Re: Loft @ 1801

1801 Mesa Vista Rd. NE Traffic Circulation Layout

RE: TCL Submittal Comments

TRAFFIC **CIRCULATION** LAYOUT

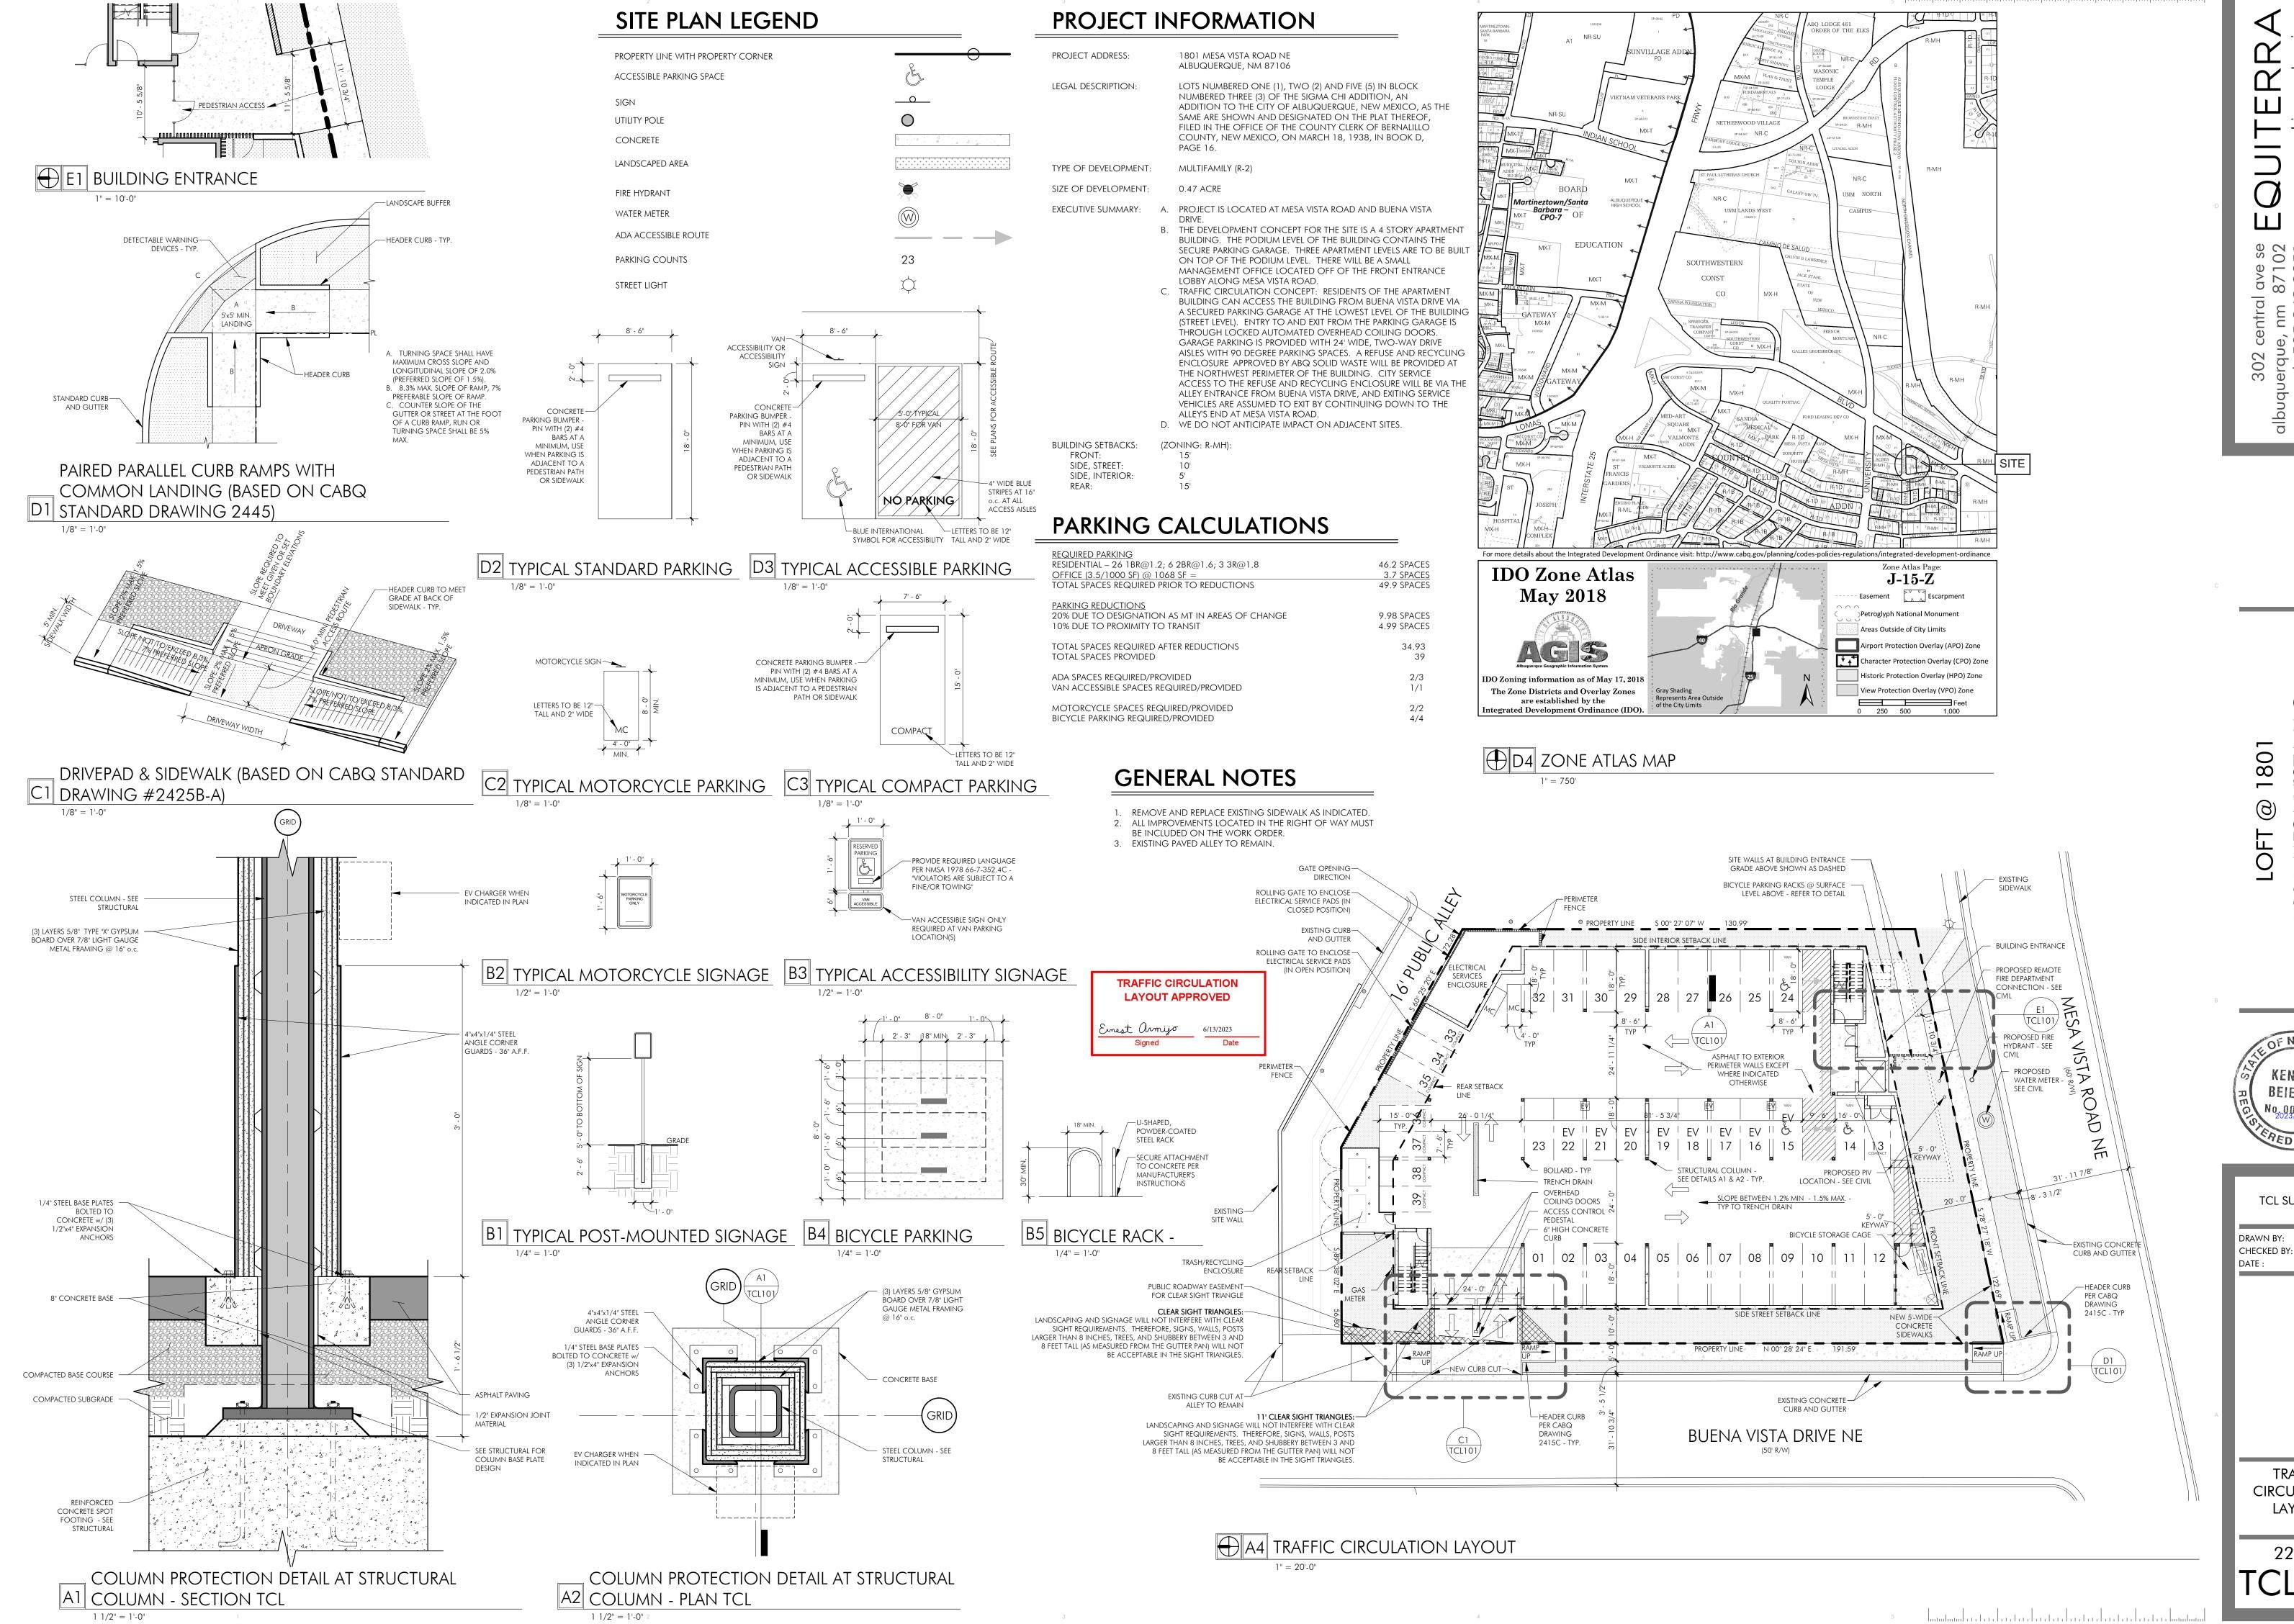
- 1. A 5 ft. keyway is required for dead-end parking aisles. Please show this dimension on the site plan.
- a. We have added the dimension showing the 5' keyway. Please note the south wall angles relative to the parking/drive aisle. The 5' keyway is maintained as a minimum.

- Please clarify, what is the purpose of the electric gate, and is there an access off the public Alley? If so, the full width of the alley shall be paved from the parking access drive to a street, per the city standards.

- Work within the public right of way requires a work order with DRC approved plans. Please add a note on the plan stating "All improvements located in the Right of Way must be included on the work order."

- a. The rolling gate will provide access to the enclosure that holds the PNM transformer, CT Meter and Main Building Disconnect. We do not anticipate anyone needing regular access. Regardless, the alley is currently paved along it's entire length and we have added General Note 3, stating that the paved alley is to remain.

- a. Please see General Note 2, "ALL IMPROVEMENTS LOCATED IN THE RIGHT OF WAY MUST BE INCLUDED IN THE WORK ORDER."
